Preliminary Consultation
MONTGOMERY COUNTY HISTORIC PRESERVATION COMMISSION
STAFF REPORT

Address:	37 West Irving Street, Chevy Chase	Meeting Date:	7/29/2020
Resource:	Contributing Resource Chevy Chase Village Historic District	Report Date:	7/22/2020
		Public Notice:	7/15/2020
Applicant:	Roslyn Mazer and David Holzworth (Jonathan Kuhn, Agent)	Tax Credit:	N/A
Review:	Preliminary Consultation	Staff:	Michael Kyne
Case Number:	N/A		
PROPOSAL:	Building addition

SHEET NAME
PROPOSED
RENDERING

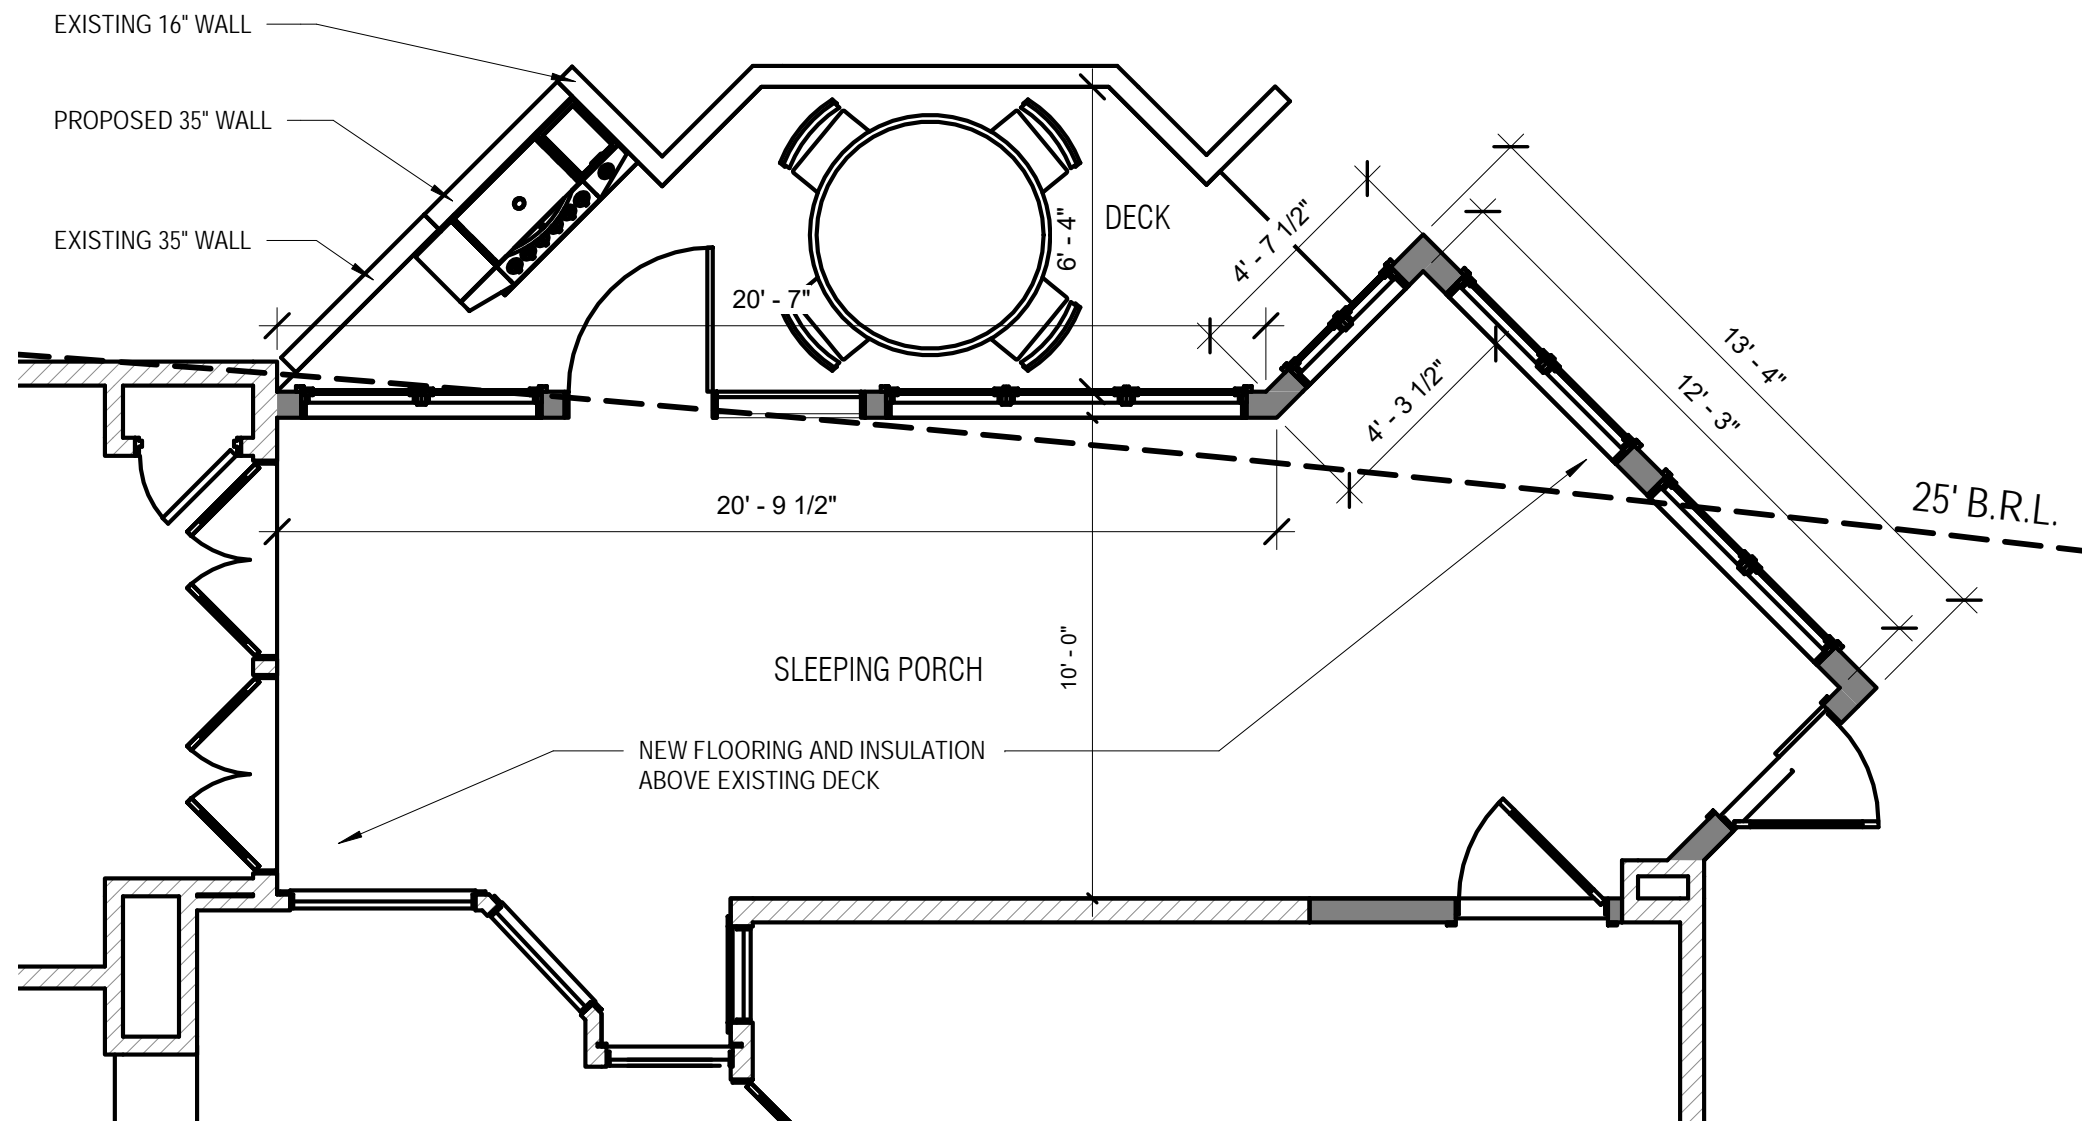
Staff asks for the Commission’s guidance regarding the compatibility of the proposed sleeping porch with the surrounding streetscape. Specifically, staff asks for guidance regarding the angled northwest wall of the proposed addition, which will result in a non-traditional building form, which is generally inconsistent with the symmetrical historic house. Staff also asks the Commission to provide general guidance regarding appropriate and compatible materials for a highly visible addition, which will be experienced as a front/side addition from the public right-of-way.

1 PROPOSED FIRST FLOOR_ (PARTIAL)
1/4" = 1'-0"

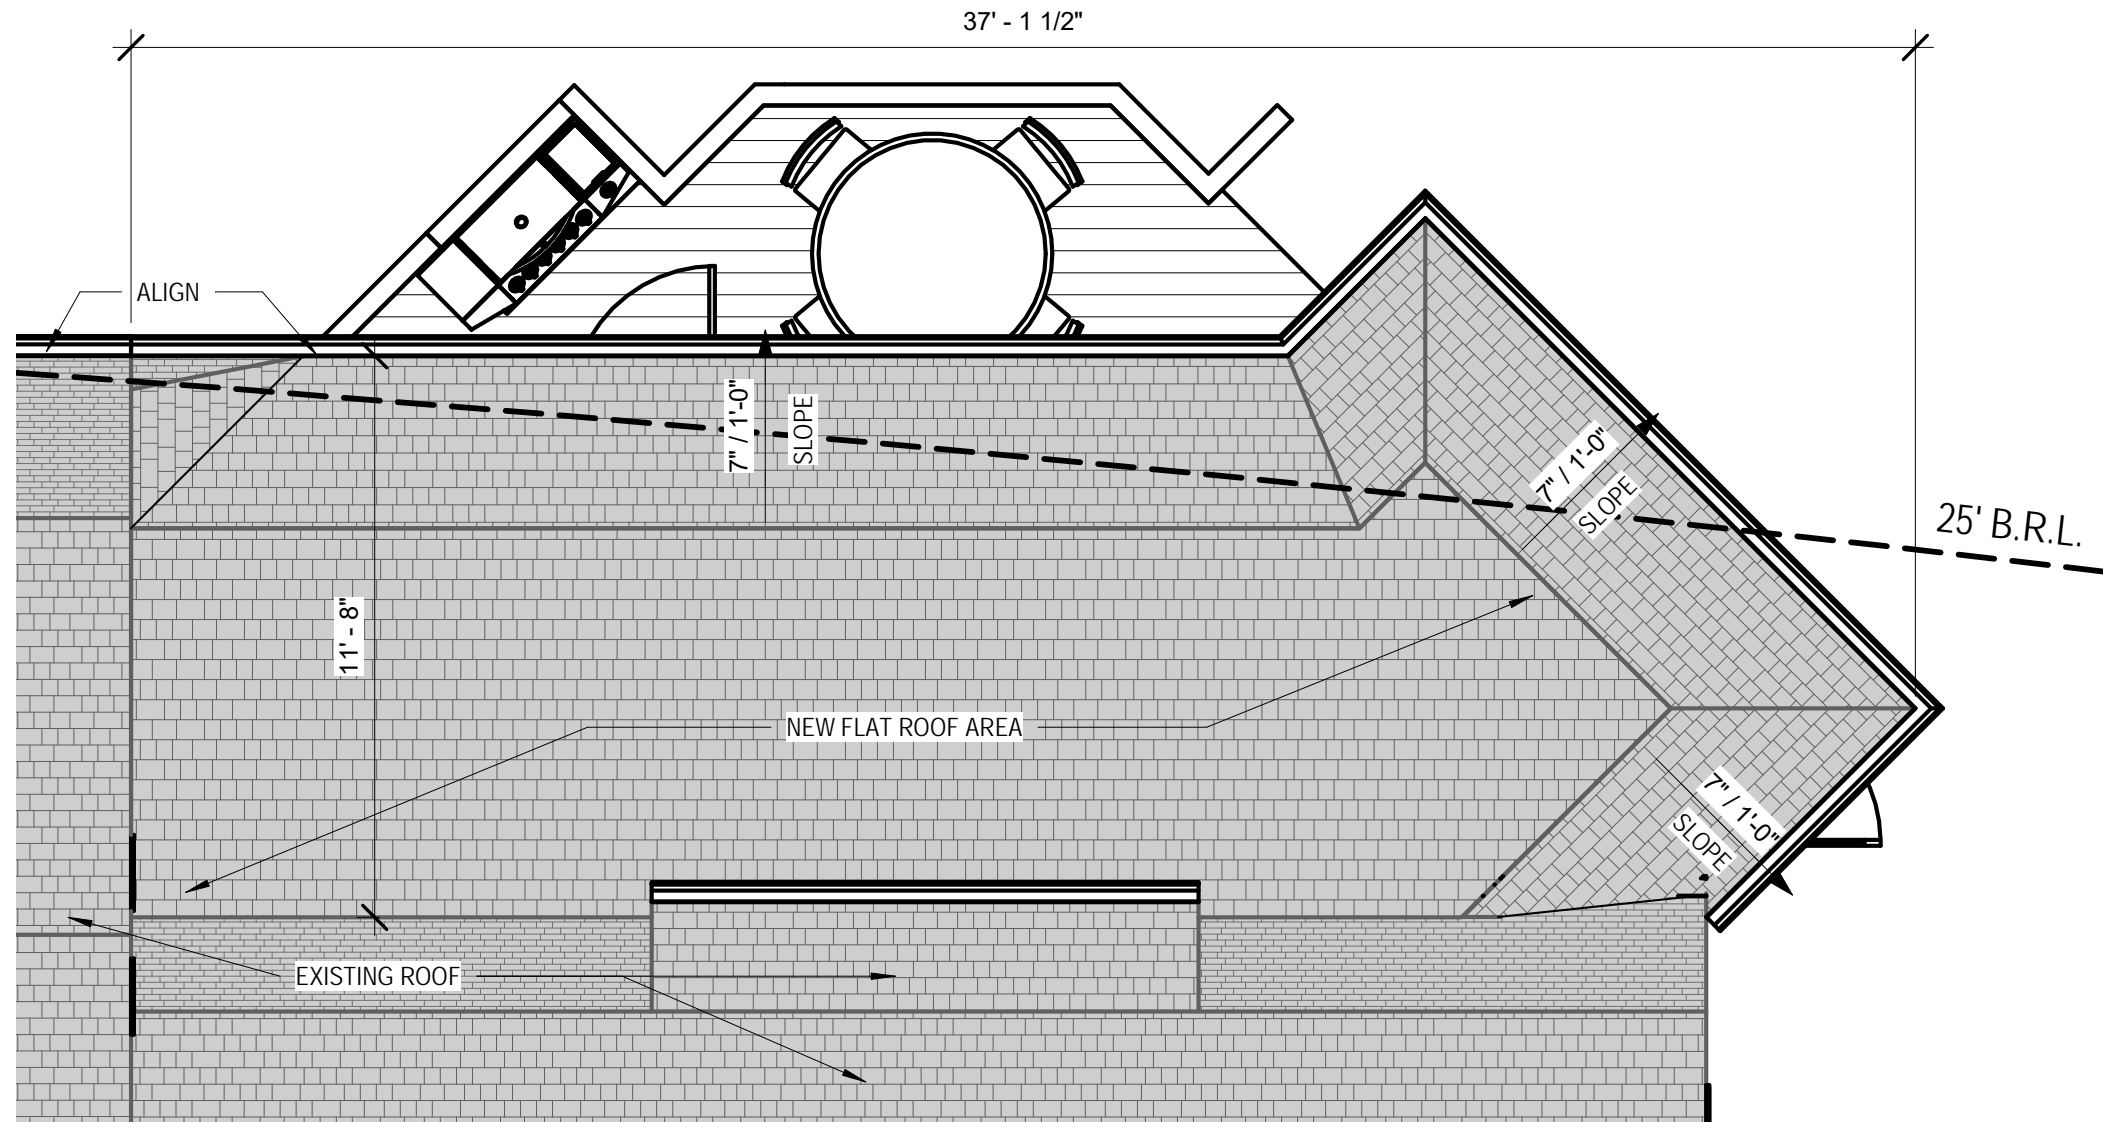
The applicants propose to construct a one-story sleeping porch addition at the west side of the existing non-historic addition within the footprint of the existing non-historic deck. The northwest corner of the deck is angled, and the northwest wall of the proposed sleeping porch will follow this angle, resulting in a non-traditional building form.
